Economic Commission for Europe**Inland Transport Committee****Working Party on the Transport of Perishable Foodstuffs****Seventy-sixth session**

Proposals of amendments to ATP:**new proposals****Proposals for amendment of the ATP by the informal working group on the improvement of the approval system of ATP equipment and thermal appliances****Transmitted by the Government of the Netherlands on behalf of the informal working group***Summary*

Proposal 1 – Date of construction/manufacture

Proposal 4 – Multi Temp-Multi Compartment equipment

Model No. 14

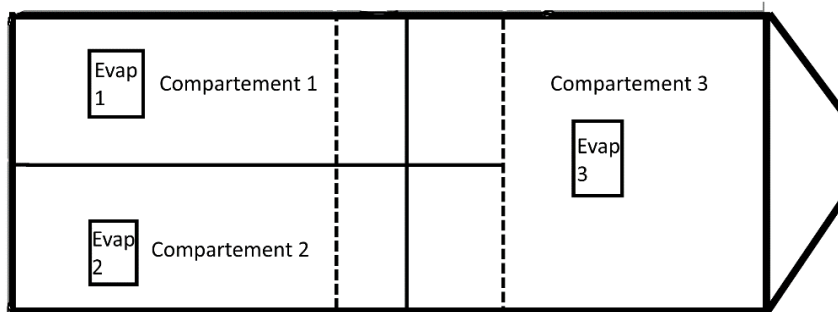
“The declaration shall conform to the lay-out given in Model No. 14 of this Appendix.”
13. In Annex 1, Appendix 2 section 8 add a new Model No. 14 as reproduced in the Annex to this document.

Declaration of conformity for Multi Temperature – Multi compartment equipment
